**ADDENDUM # 2**

<b>Project</b>	TA Blakelock High School Renovations	<b>Project No.</b>	2215-B
<b>Location</b>	1160 Rebecca Street, Oakville, ON	<b>Date of Issue</b>	2024 04 19
<b>Owner</b>	Halton District School Board	<b>File</b>	2215/7.1.3

This Addendum forms part of the Contract Documents and amends the original Drawings and Specifications, dated 2024 04 11, and all preceding Addenda, as noted below.

**MILLWORK DETAILS**

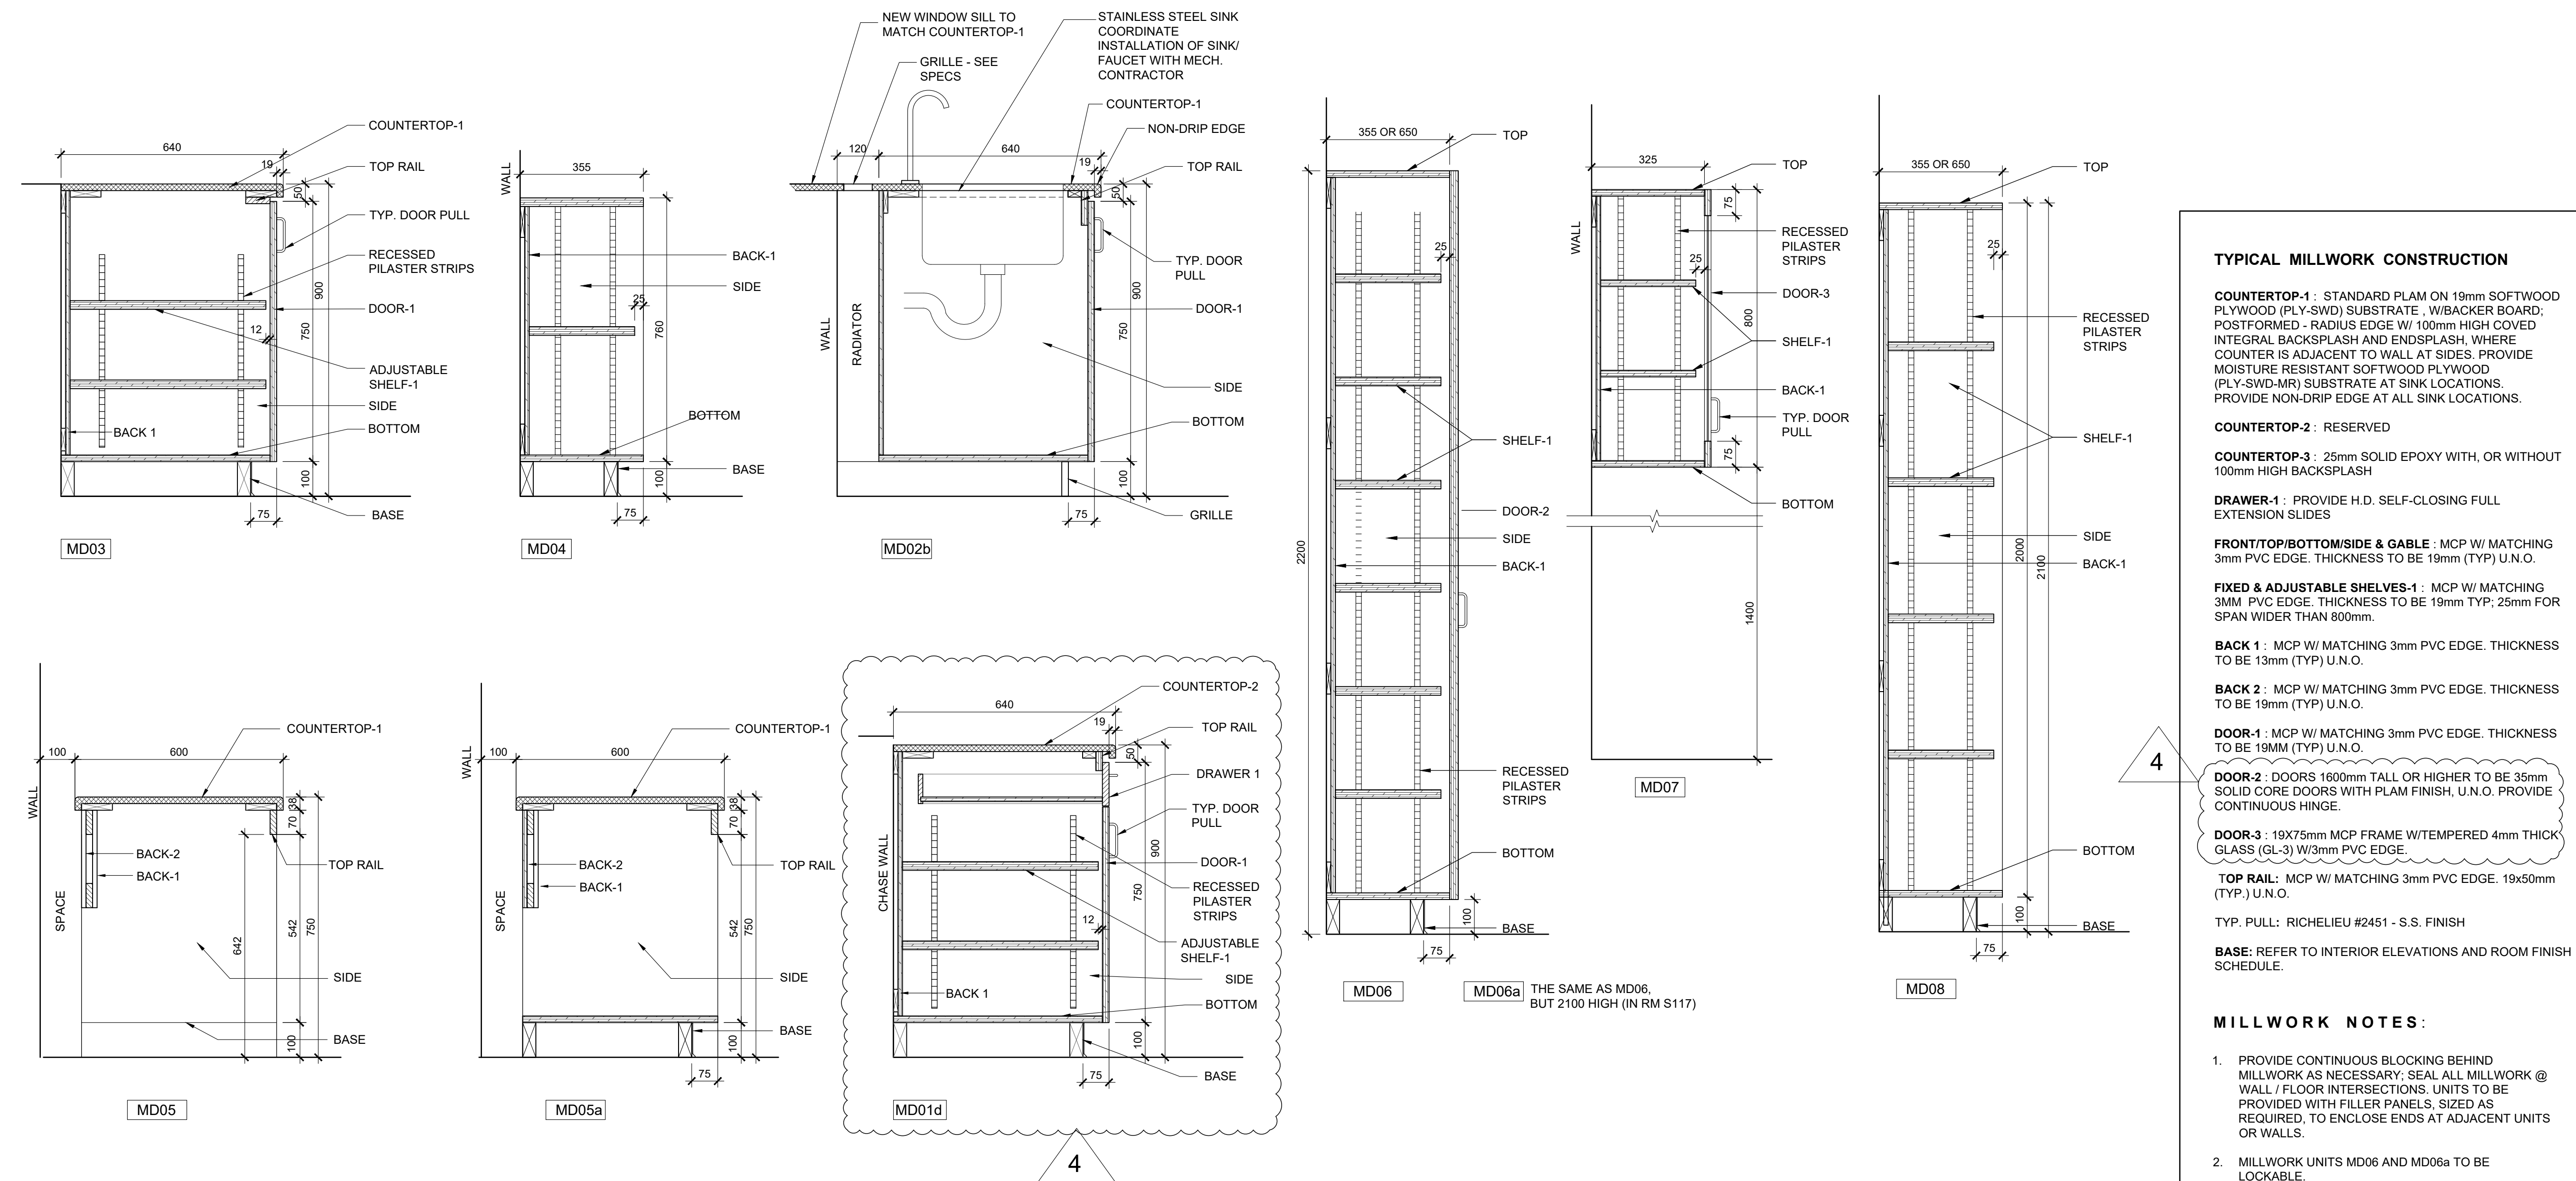
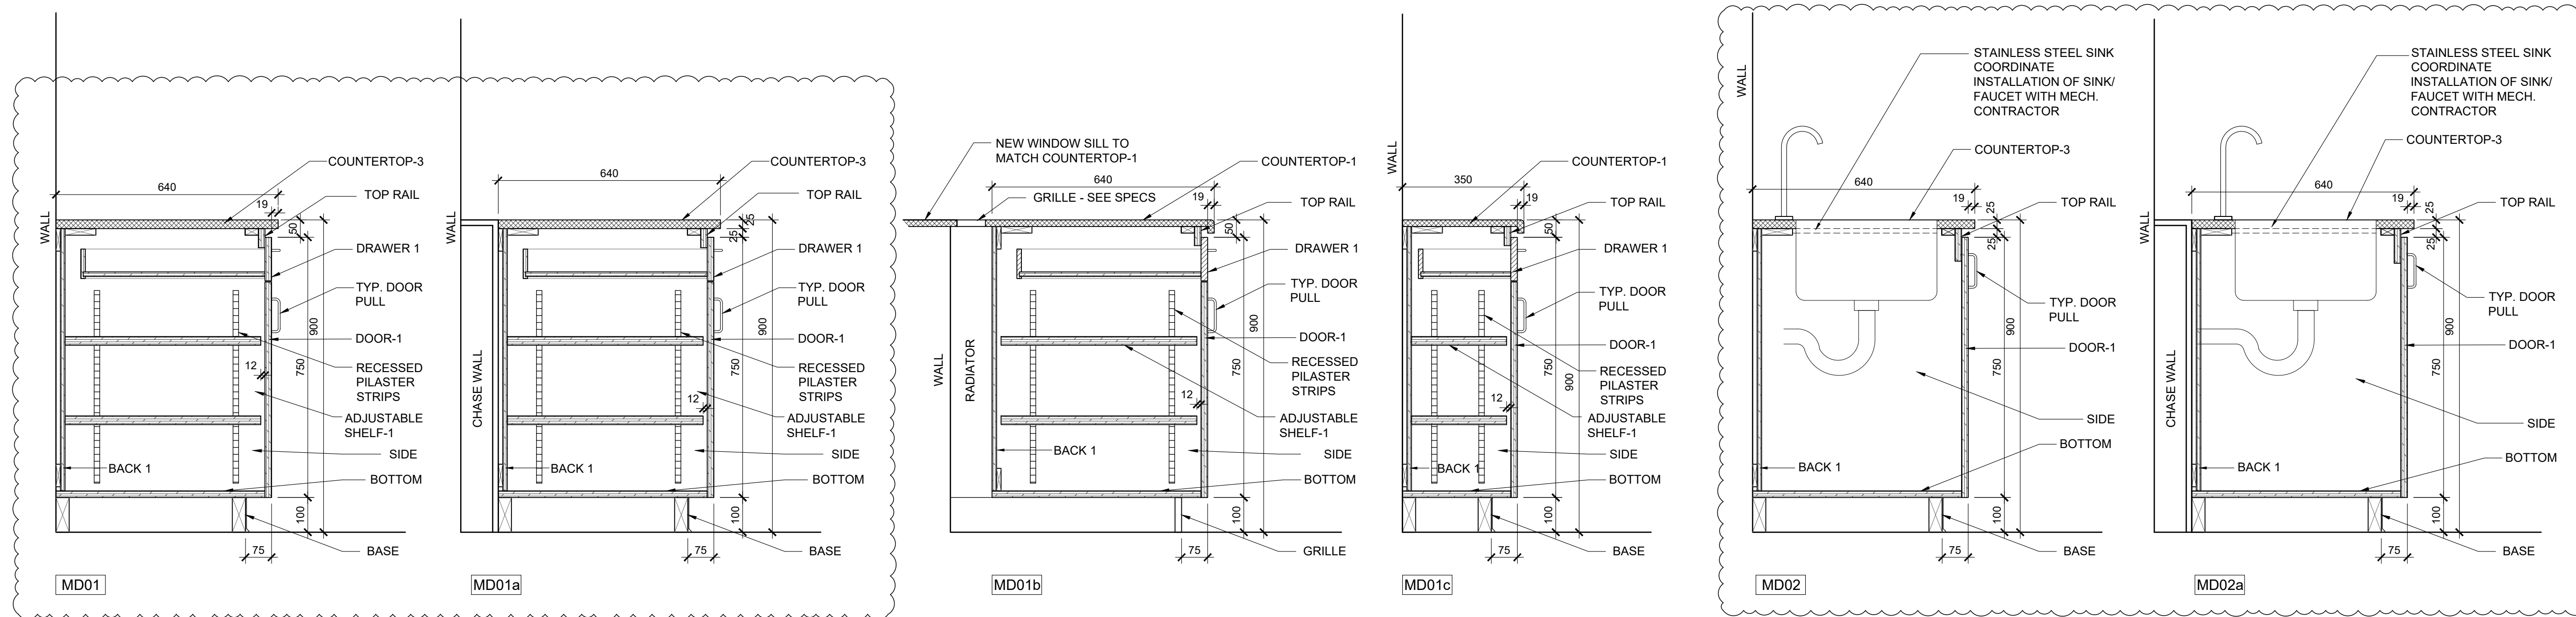
**3. Drawing A106 Millwork Details**

.1 Counter tops in Millwork MD01, MD01a, MD02, MD02a were revised to epoxy.

.2 Millwork detail MD01d was added to the drawing.

.3 Notes for Door-2 and Door-3 were revised.

7. Q: Regarding Door 3 is this door one piece with a routed cutout for the glass to be silicone?

8. Q: Regarding Door 2 it is going to be hard to find 3mm PVC wide enough for the 35mm thick door, these will also require fillers between the cabinets as it will hit the other cabinet. Would you consider a 3/4 door being there not that large and don't require a door lock set?

A: The door includes 4mm tempered glass glazing (GL-3). Include glazing stop on one side.

A: Edge banding to be HPL to match face.

REVISED LOCATIONS OF WORK AREAS

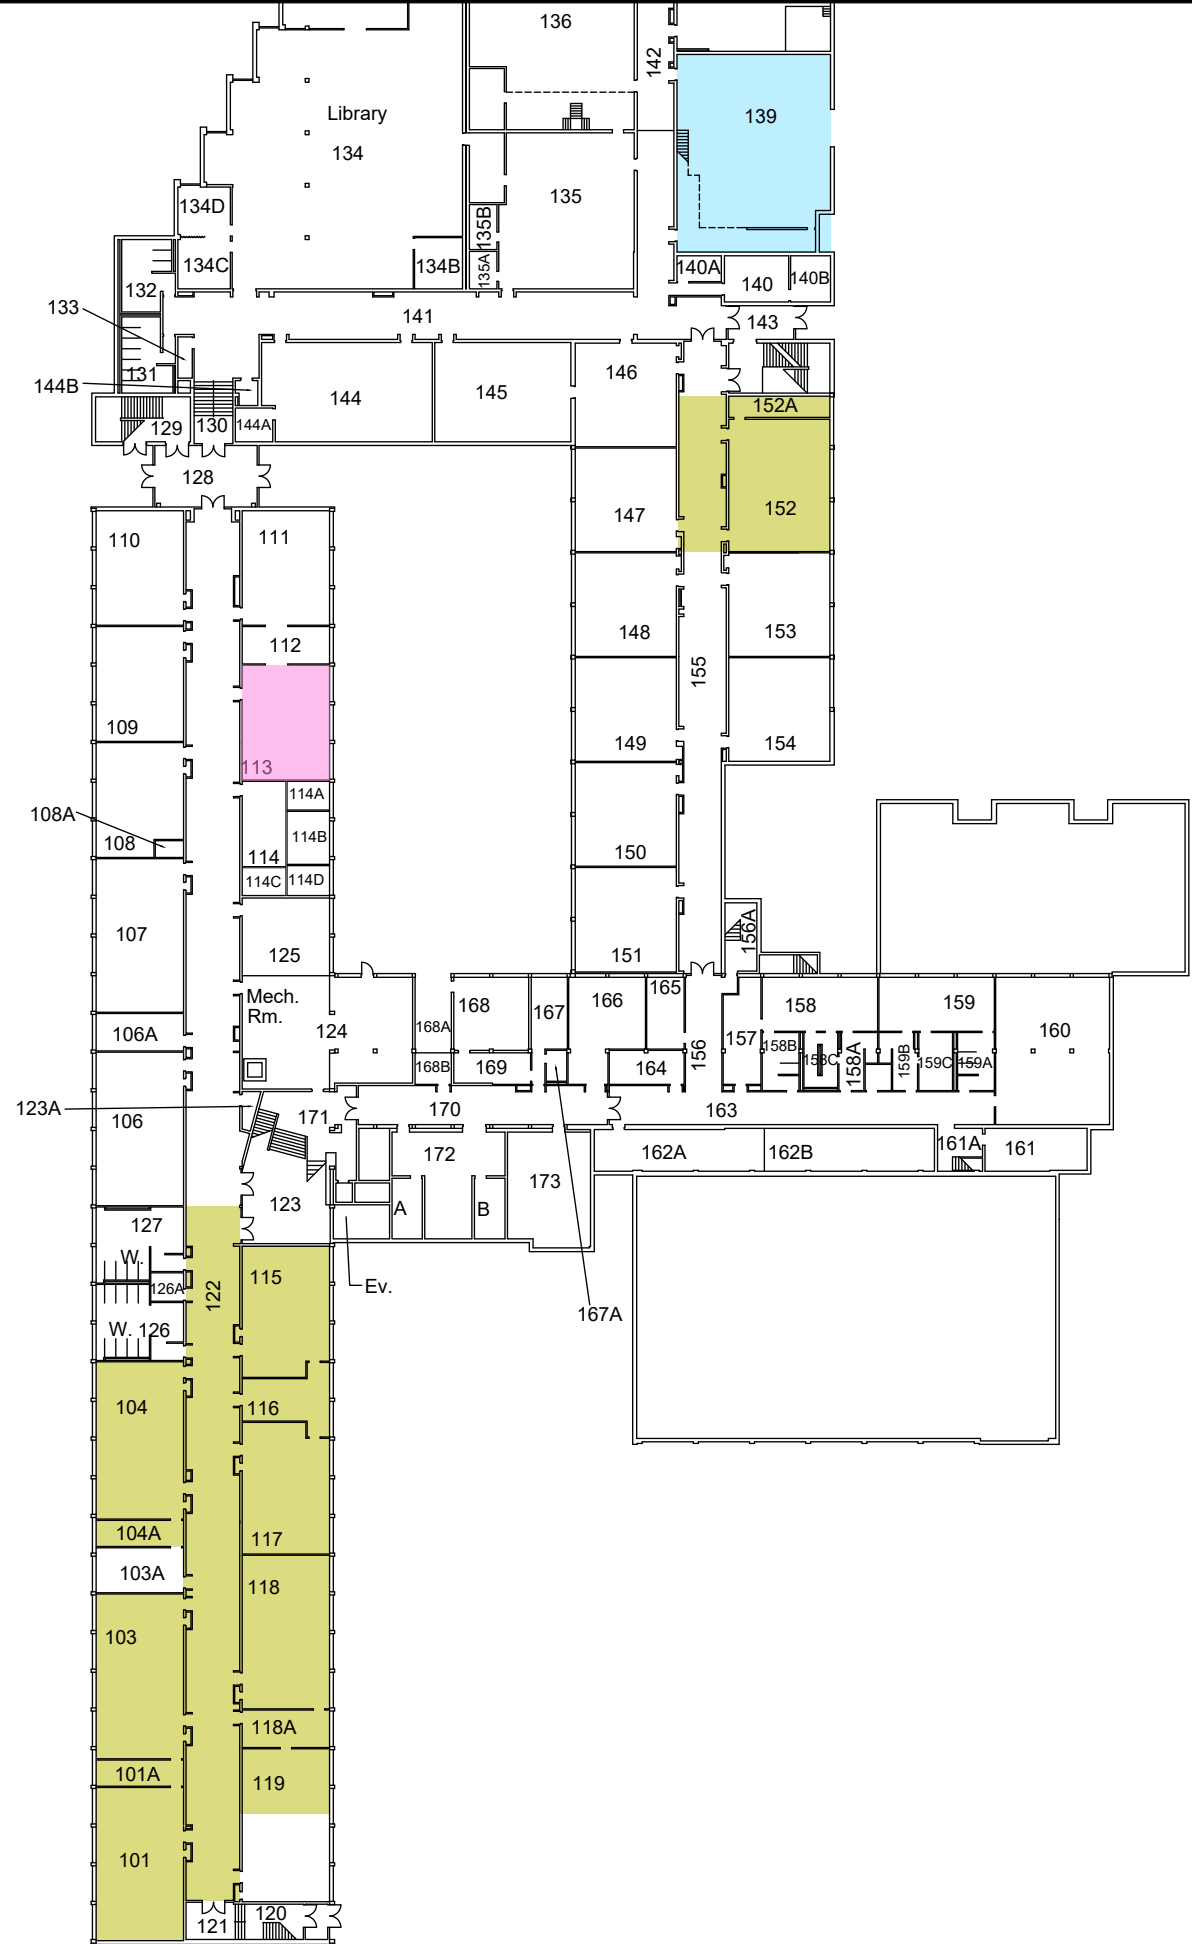
Delete the following Drawings:

30217738-1 - Locations of Work Areas First Floor Plan  
30217738-2 - Locations of Work Areas First and Second Floor Plan

Replace with the following attached Drawings:

30217738-1 - Revised Locations of Work Areas First Floor Plan  
30217738-2 - Revised Locations of Work Areas First and Second Floor Plan

**AREA 3 (FLOOR BELOW) - PROPOSED P&D**

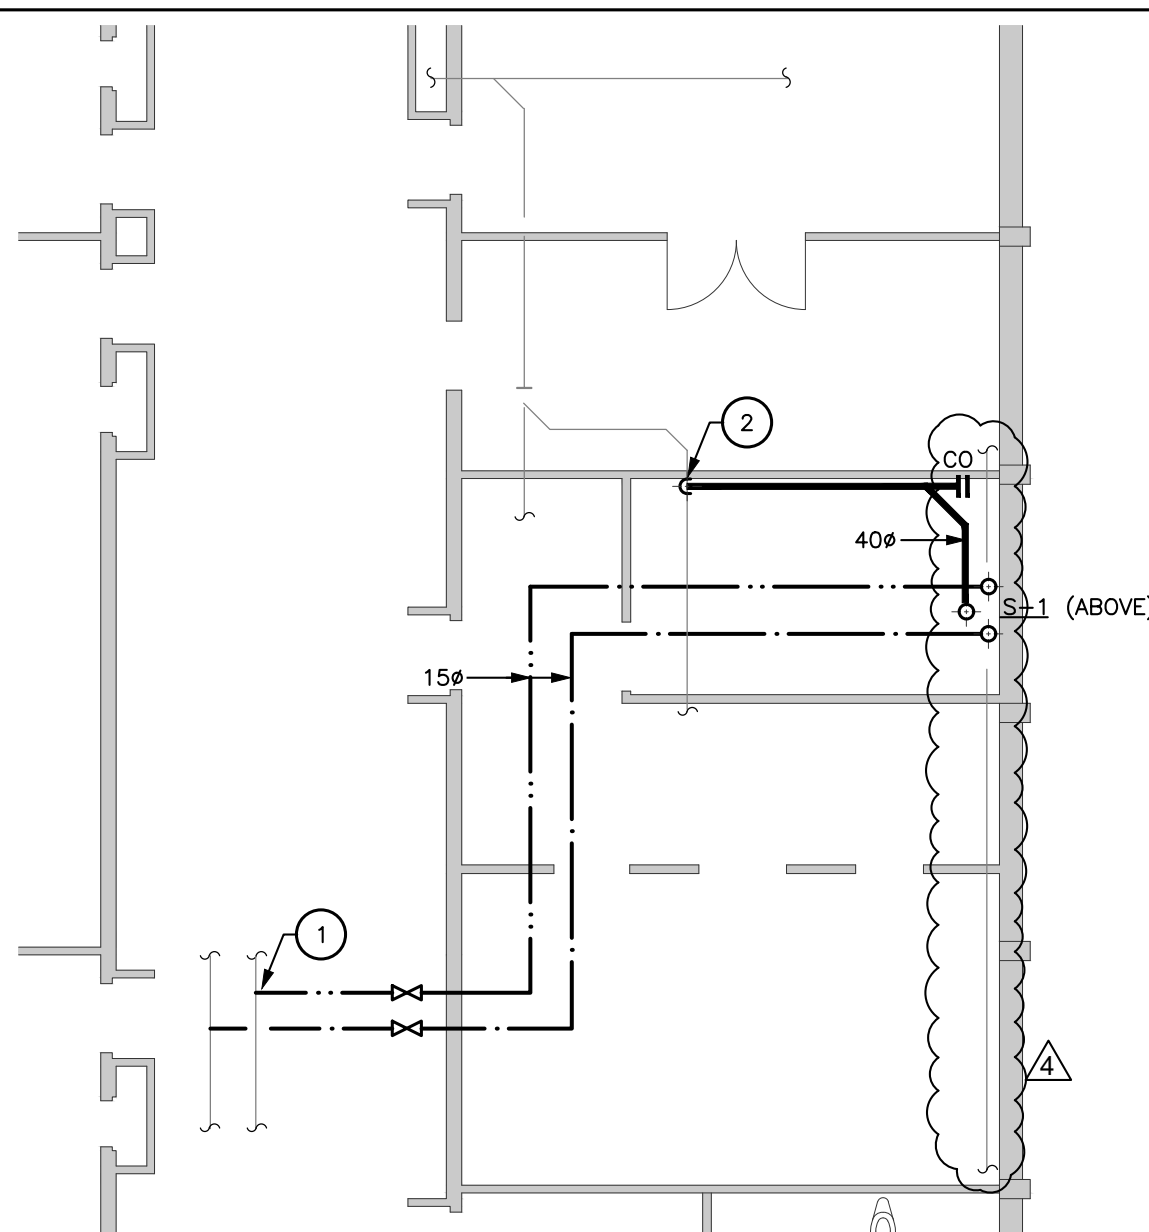
2. **Drawing M101 – PROPOSED PLUMBING & DRAINAGE PLAN**

- .1 Drawing is issued with this addendum. Modifications include, but are not limited to the following:
- .2 **Refer to 4/M101 – AREA 3 (FLOOR BELOW) – PROPOSED P&D:**

- .1 **ADD** Note 3 calling for reinsulating of existing piping under asbestos abatement.
  - .2 **ADD** Items not captured on drawings; Modifications to include, but are not limited to the following:
